Public Service Commission

June 13, 2019

The North Dakota Public Service Commission (Commission) has reviewed your filing, dated May 15, 2019, regarding your land located in the NW $\frac{1}{4}$ of Section 34, T146N, R88W.

Complaint No. 1: *Constructed a diversion ditch on farmland creating a new affected area outside the permit area without a PSC permit revision and without Landowner consent, no associated reclamation plan or performance bond, and resulted in loss of crop income.*

PostMine Topography, Landuse and Imagery above NW1/4 34, T146N, R88W

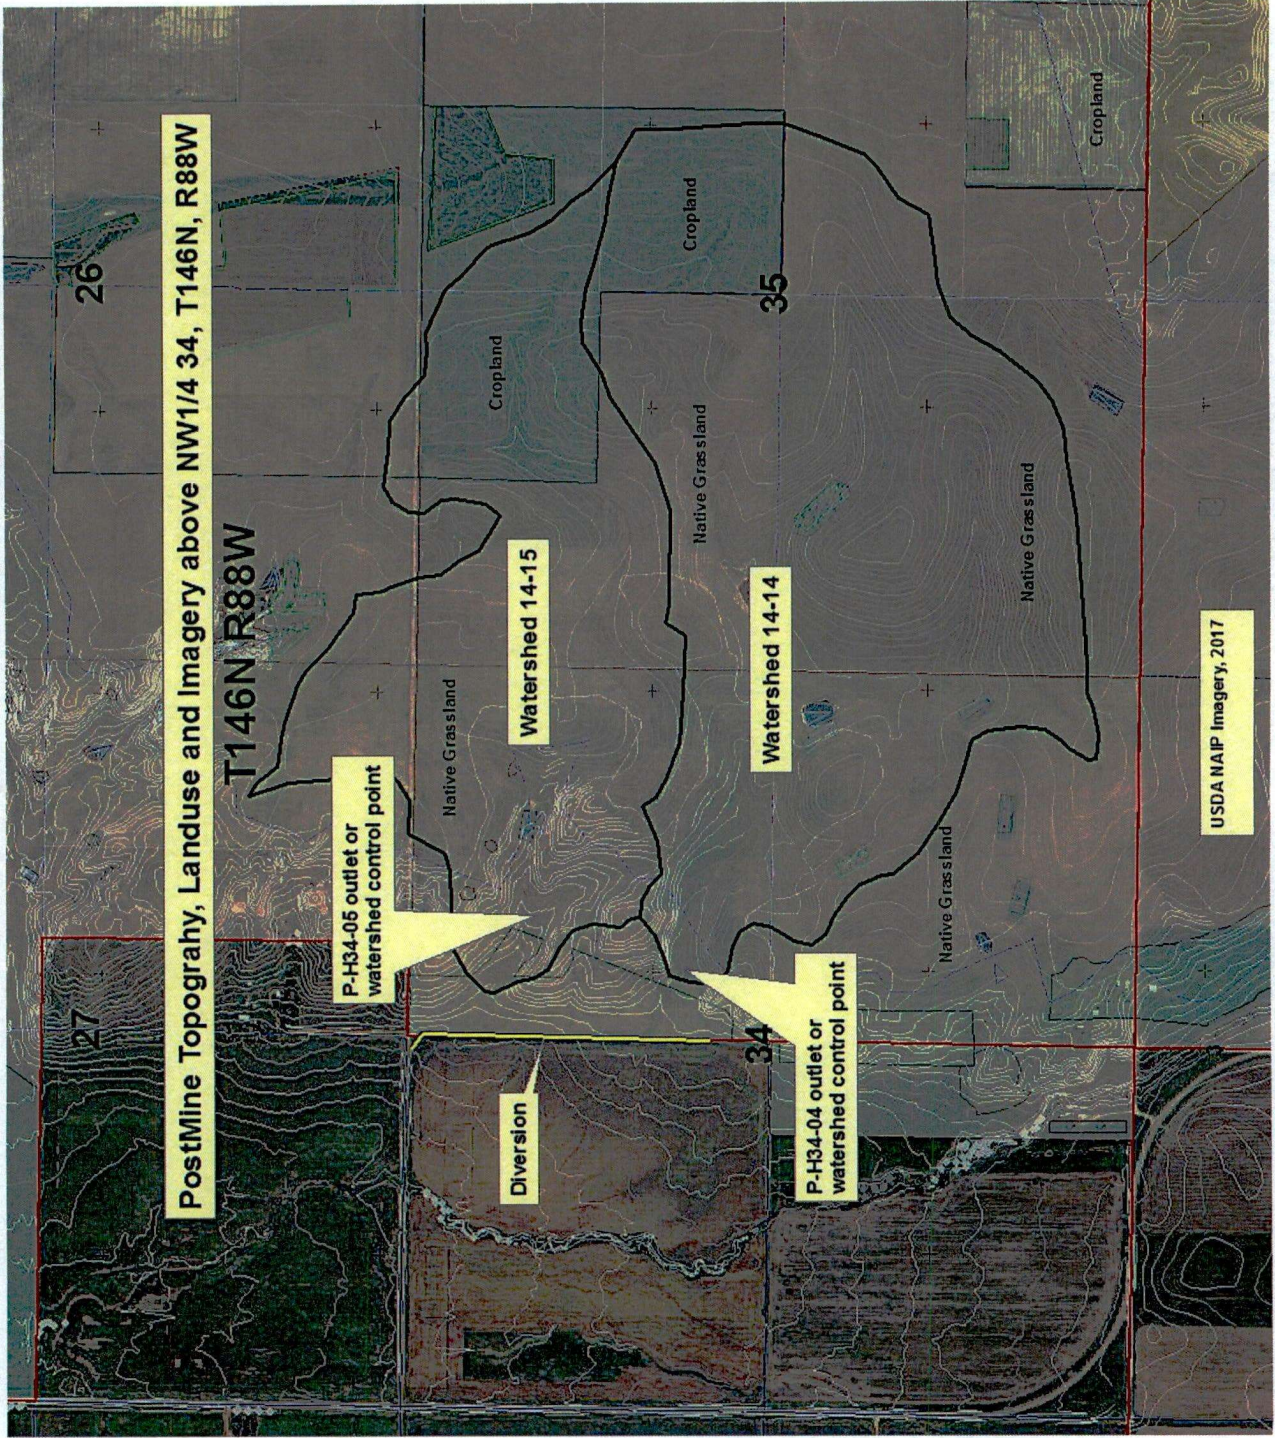
Our analysis shows that even though the total combined watershed size increased after reclamation, the expected total flow rates and volumes are less than the premine condition. This is due to a number of reasons but is primarily due to the reclaimed or postmine watersheds being less steep than the premine watersheds. The premine average slope of watershed 14-15 was 12.7% and the postmine average slope is 4.4%. In addition, the soils with a higher runoff potential (shallow and claypan soils) that were common in the premine watershed were replaced with deeper, loamy soils with higher infiltration rates and lower runoff potential. In addition, there is less cropland and more native grassland in the reclaimed watershed than in the premine watershed. The perennial native grassland vegetation generally has a lower runoff potential than cropland.

Our analysis shows that even though the total combined watershed size increased after reclamation, the expected total flow rates and volumes are less than the premine condition. This is due to a number of reasons but is primarily due to the reclaimed or postmine watersheds being less steep than the premine watersheds. The premine average slope of watershed 14-15 was 12.7% and the postmine average slope is 4.4%. In addition, the shallow and claypan soils that were common in the premine watershed were replaced with deeper, loamy soils with higher infiltration rates. In addition, there is less cropland and more native grassland in the reclaimed watershed than in the premine watershed. The perennial native grassland vegetation generally has a lower runoff potential than cropland.

Global Summary Results for Run "Run 10-24"

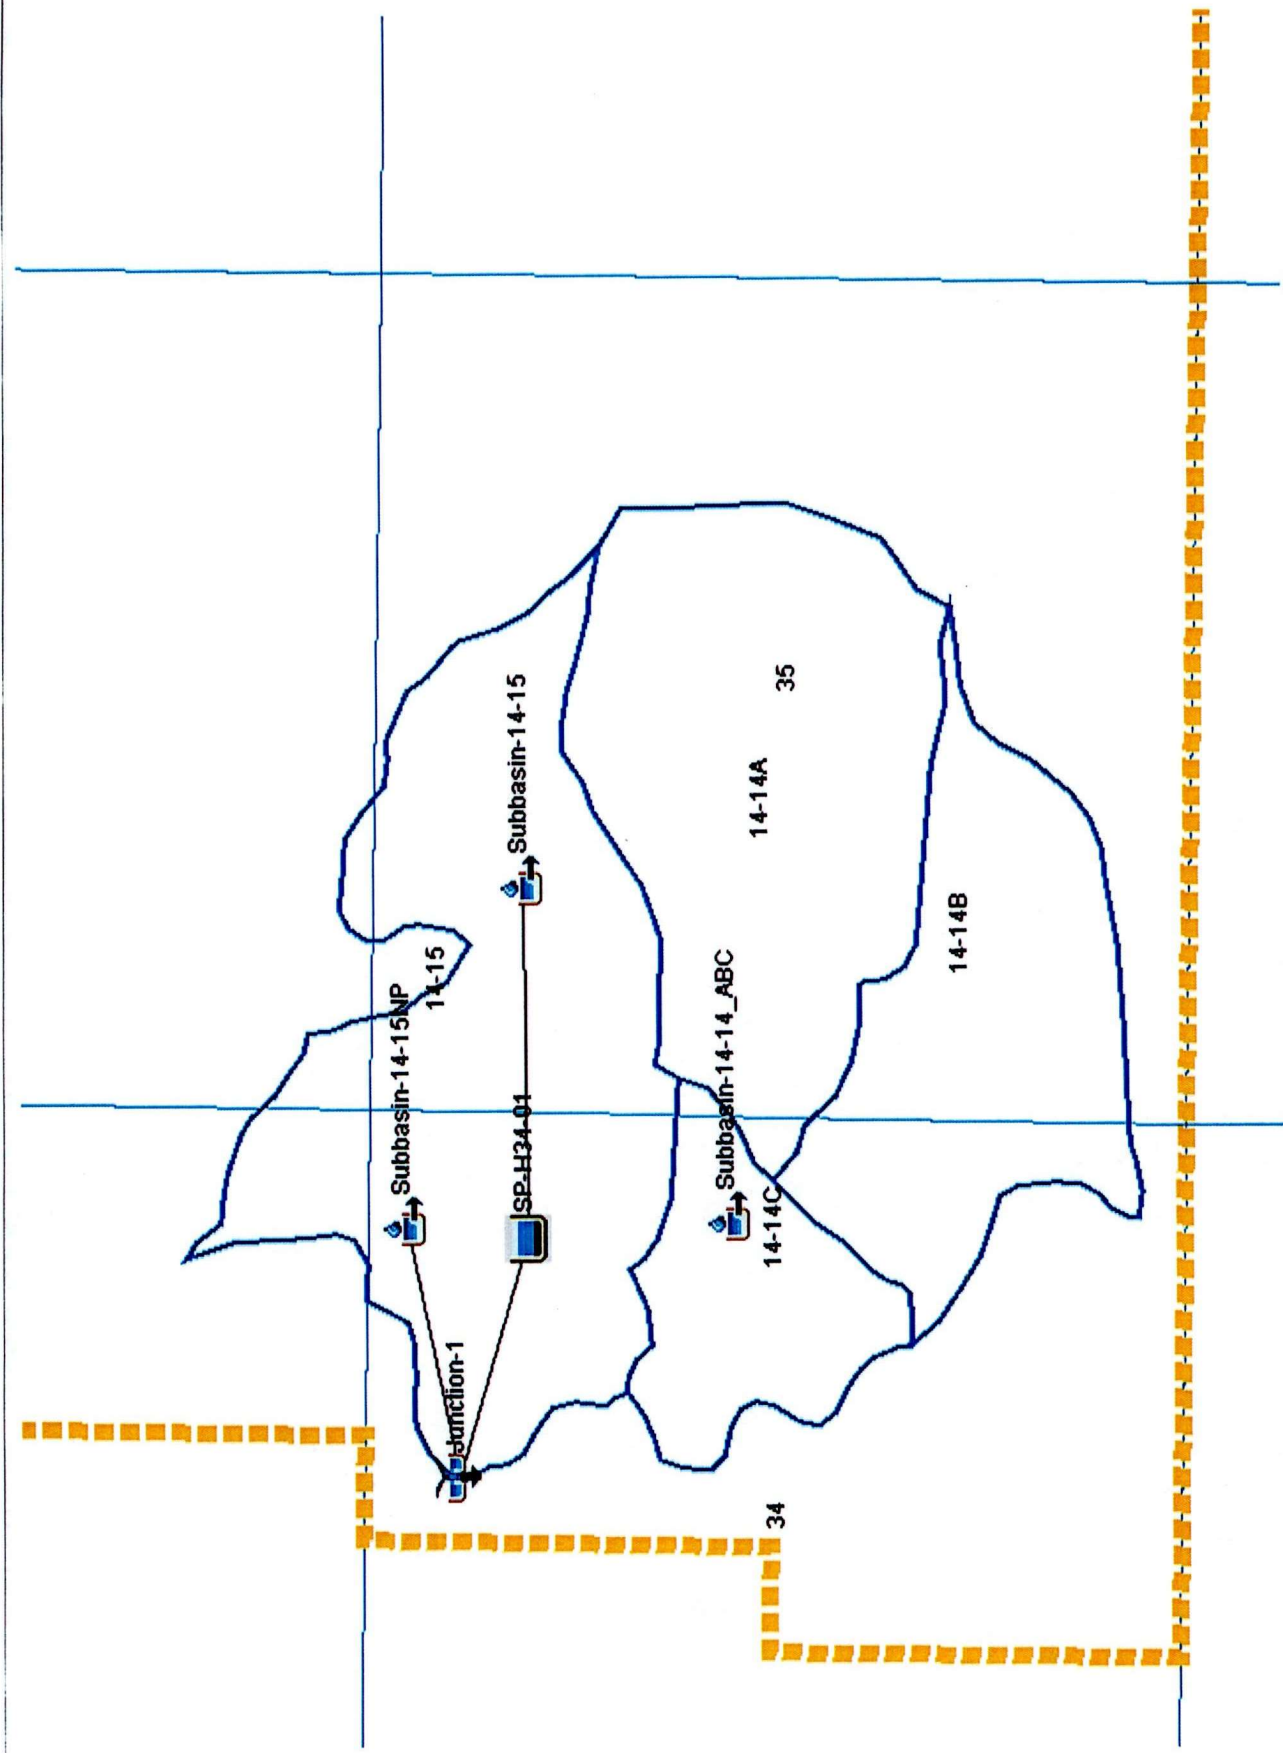
As part of our review of Revision No. 30, Reclamation Division staff have reviewed the flow modeling provided by Coteau and have determined the parameters and assumptions used were appropriate and reflected the actual conditions. In response to your concerns, staff again modeled both watersheds and the results of our independent modeling are similar to those provided by Coteau in Revision 30. The results of our modeling are also included in Attachment 1.

The Reclamation Division staff have reviewed the flow modeling provided by Coteau and have determined the parameters and assumptions used were appropriate and reflected the actual conditions. In response to your concerns, staff again modeled both watersheds and the results of our independent modeling are similar to those provided by Coteau in Revision 30. A copy of our analysis is attached.

FIGURE 3

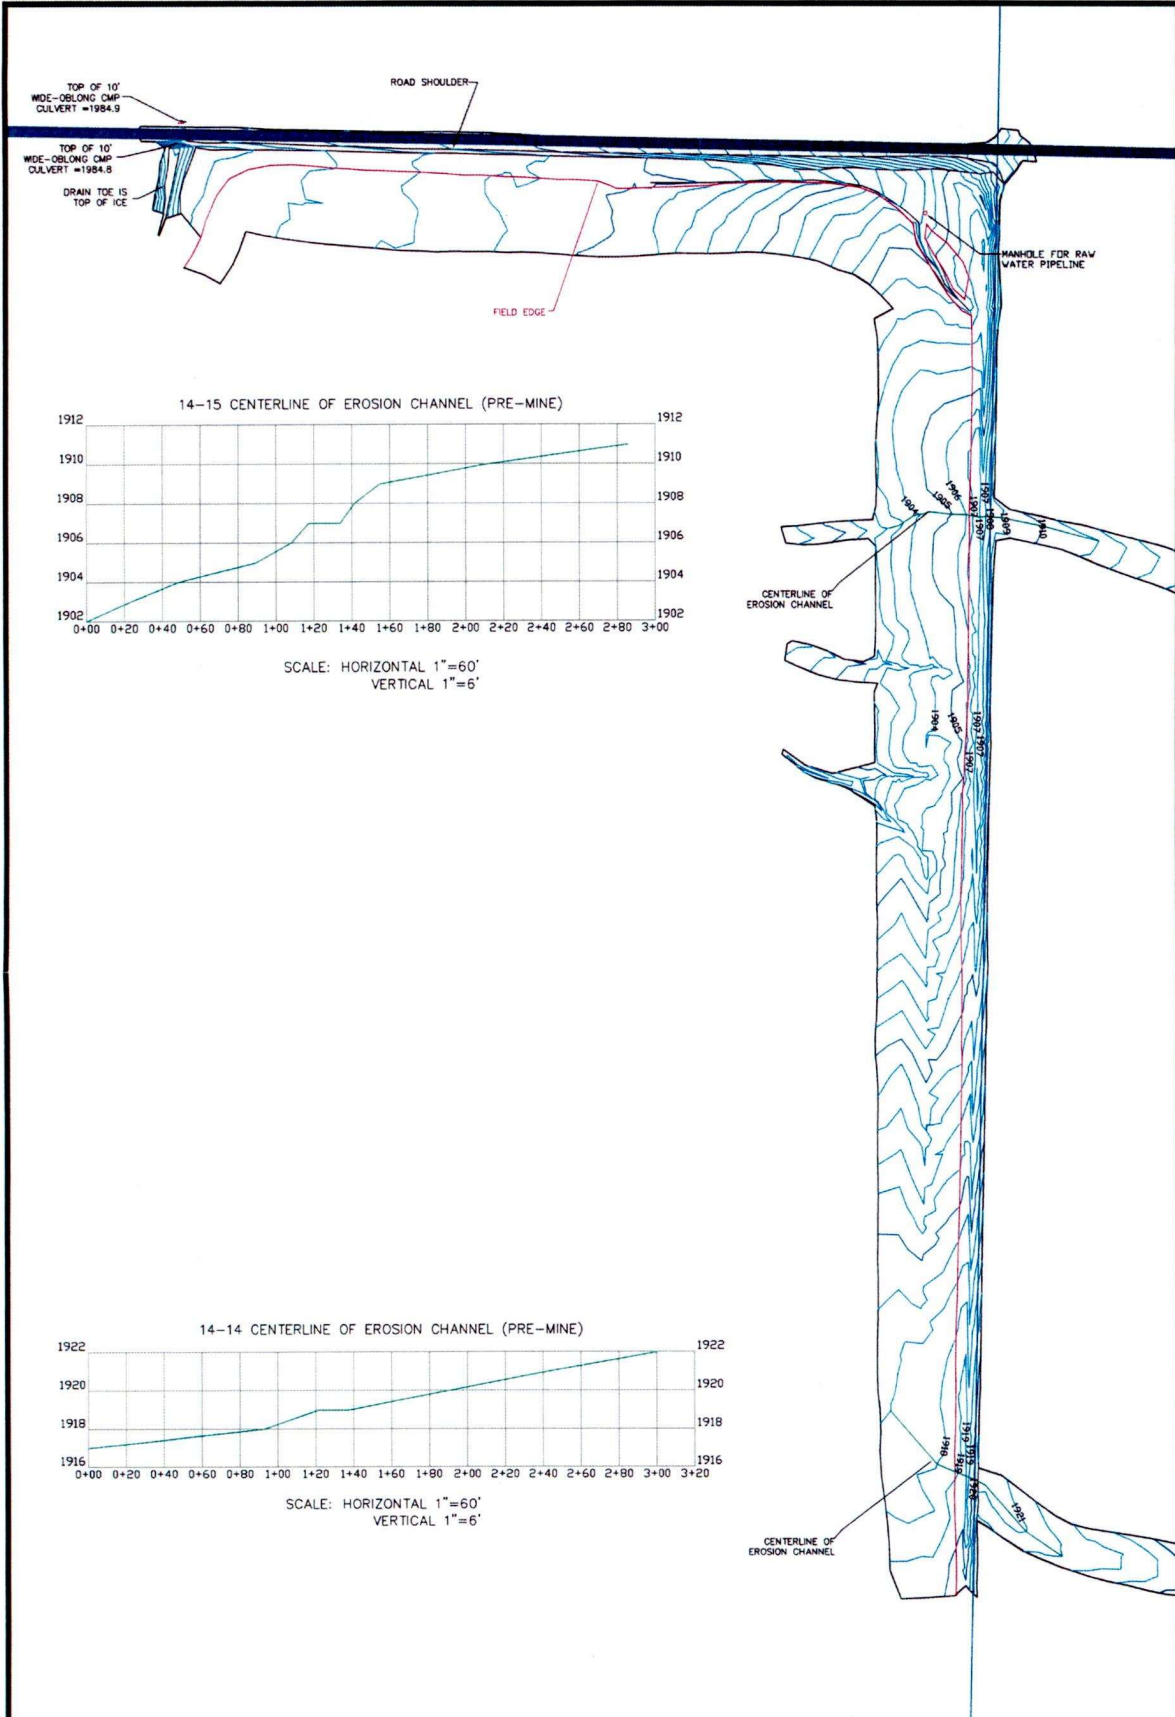
The producer approached Coteau in both 2010 and 2011 about aiding in repairing erosion in the field while the sediment ponds were in place and functioning. Additionally, Figure 3 is the original ground topography survey prior to reconstruction of the diversion. As can be seen in the drawing, there are several areas that show erosion west or below the diversion. Figure 3 includes two cross-sections of the existing diversion, one at the entrance of watershed 14-14 and one at the entrance of watershed 14-15. Both cross-sections indicate that runoff would flow across the diversion to the west uninterrupted. This survey was collected on November 29, 2011, after installation of the sedimentation ponds, but prior to the reconstruction of the diversion or removal of any sedimentation ponds.
